Subject: SQUG Advisory 2004-01: GERS Correction for General Electric IAC66K Relay

SQUG ADVISORY 2004-01: GERS Correction for General Electric IAC66K Relay

Seismic Ruggedness of Relays, Electric Power Research Institute, EPRI NP-7147, Volume 2: Addendum 2, April 1995.

Figure 1 IAC66K Relay Internal Configuration

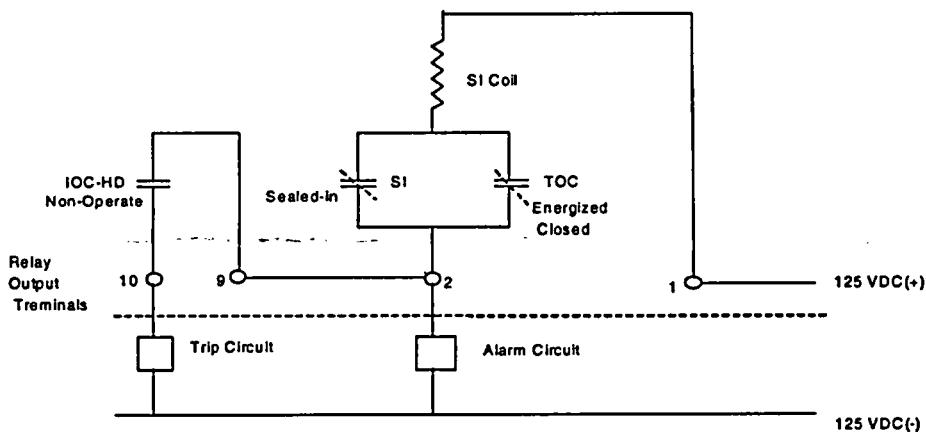
The IAC66K is actually three separate sub-component relays wired together to operate as a system. Each sub-component relay operates at different levels of input AC current to close its respective normally open contact. First, the time overcurrent (TOC) unit is a standard induction disk relay (designated as inverse, long time) that takes several seconds to operate. The TOC unit is set to begin timing operation at a low AC current setting. When this low current setting has been exceeded and the induction disk has finished its rotation, the TOC contact closes which energizes the coil of a target & seal-in (SI) relay, which closes an additional contact that is wired in parallel with the TOC contact. When the SI contact is closed, the SI relay coil is energized by its own contact, and the circuit is said to be sealed-in. The TOC contact can chatter or even open, but the SI contact remains closed. The output of the TOC/SI contact set is used as an alarm indication only. Next, a high dropout instantaneous overcurrent (IOC-HD) relay is set to operate at an intermediate current level. The IOC-HD output contact is wired in series with the TOC/SI contact set and connected with the plant DC control circuit for switchgear tripping. Thus, for the series contact pair to have an output, the contacts of **both** units must be closed. If the IOC-HD contact chatters and the TOC/SI contact set is open, then the DC circuit is still open and the chatter cannot affect the switchgear trip circuit. Likewise, chatter of the TOC/SI contact set can only affect the switchgear trip circuit if the IOC-HD contact has simultaneous chatter. If the TOC/SI contact set is sealed-in, then IOC-HD contact chatter can cause spurious switchgear operation. Finally, a separate instantaneous overcurrent (IOC-N) relay is set to operate at a high current. The IOC-N contact is directly connected to the switchgear trip circuit, thus IOC-N contact chatter can directly cause spurious switchgear operation.

The consequences of the GERS typographical error for the IOC-HD subcomponent of the IAC66K will depend upon how the results were utilized in A-46 relay reviews. If the minimum value of 5 g indicated in the GERS report for the TOC/SI unit was used as the non-operate fragility of the relay, then there is no issue concerning the actual lower fragility of the IOC-HD unit being less than 5 g, since the output contacts of the pair of units are connected in series and the non-operate fragility of the series pair is 5 g. However, if the relay evaluation recognized the series contact pair and concluded that the relay fragility in the non-operate mode was governed by the highest fragility level, then the use of the 10 g value erroneously indicated for the IOC-HD would result in an incorrect non-operate fragility for the relay. In this case, the non-operate fragility of 7 g for the separate IOC-N unit would govern. For the operate mode, the 2 g value erroneously indicated for the IOC-HD unit would govern the operate relay fragility in all cases.

IAC66K Sub-Component	Non-operate NO contact	Operate NO contact
	GERS	GERS
TOC/SI [SI/TOC]*	5	10
IOC-HD [HDI]*	10 2	2 10
IOC-N [STDJ]*	7	7

Figure 1. Alternate Output Monitoring Circuit

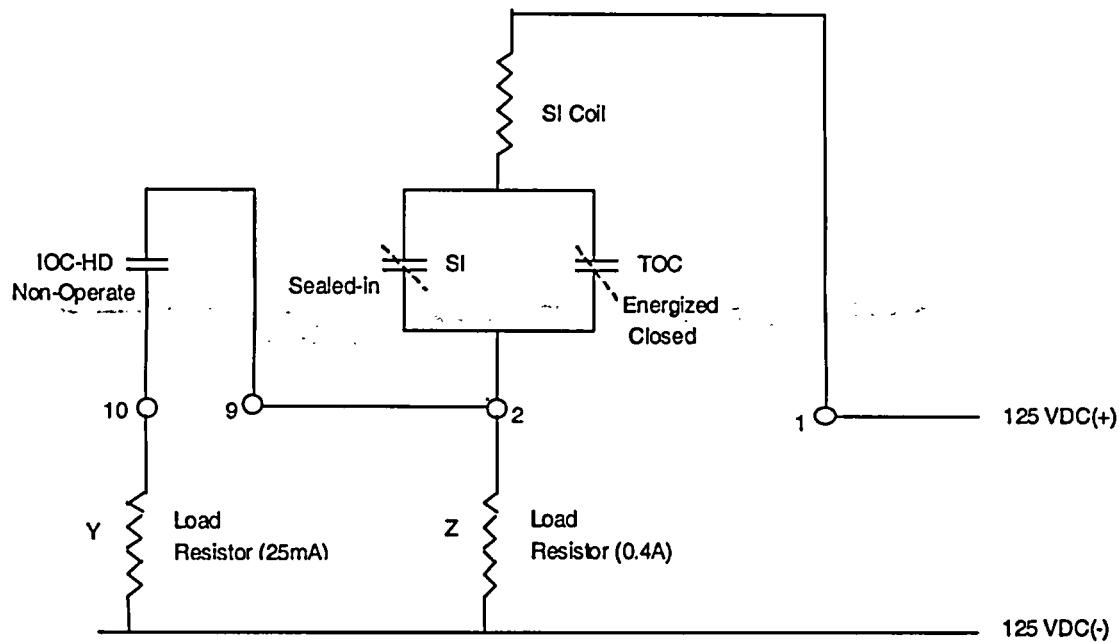
The procedure that was used in the SQUG relay testing program (Reference 2), in the case of protective relays, was to test each relay sub-component as a separate device. For the DC output circuit, the contacts of each relay were separately monitored for chatter. The alternate output monitoring circuit, shown in Figure 1, was used in the SQURTS testing of the IAC66K. In this wiring setup, the TOC/SI (terminals 1-2) and IOC-HD (terminals 2-10) contacts are wired in series to reflect how the relay is actually used rather than monitoring each contact set individually (which requires a change of internal relay wiring).

For the non-operate mode, the contact fragility (terminals 1-10) is controlled by the contact with the highest fragility of the pair. The fragility of the contact pair should be higher than fragility of either of the individual contacts since both contacts must chatter simultaneously for a series contact pair to have circuit chatter. For the operate mode, the contact fragility is controlled by the contact with the lowest fragility of the pair.

For the operate mode tests, the SQURTS testing was conducted with the relay input at 200% pull-in current of the TOC/SI, but this input current level was only approximately 75% of the pull-in of the IOC-HD, thus the IOC-HD was actually in the non-operate mode. Thus, the operate mode testing was actually conducted in the alarm state with the TOC/SI operated (and sealed-in), and with the IOC-HD in a non-operate mode. This is the contact state indicated in Figure 1. As can be noted in Figure 1, the IOC-HD is free to chatter which led to the anomalous results observed during the testing. The contact monitor indicated chatter on both the TOC/SI and IOC-HD contacts for low test input levels. Since the TOC/SI unit had operated and sealed-in, this behavior indicates that IOC-HD was chattering at a very low motion level. The apparent chatter noted on the TOC/SI is not actually a chatter, but instead a current fluctuation due to the IOC-HD loop of the monitoring circuit going in and out of the circuit when the IOC-HD contact chatters (see Figure 1). Thus, the test results are actually for the IOC-HD contact in the non-operate mode.

Based on the data available, it is judged that the fragility levels of the IOC-HD sub-component of the IAC66K is slightly greater than 2 g (4-16 Hz range) in the non-operate mode. Based on SQUG testing experience, relays designated as "high dropout" units (i.e., drop out with only a small decrease in voltage or current) tend to have low ruggedness for the normally open contact. Therefore, a conservative value of 2 g is used. It is judged that the fragility levels of the TOC/SI units are greater than 5 g (4-16 Hz range) in the non-operate mode. Based on a review of the available test data, it is apparent that the non-operate and operate GERS levels for the IOC-HD [HDI] given in Reference 1 should be interchanged to indicate that non-operate fragility level is 2 g and that the operate level is 10 g.
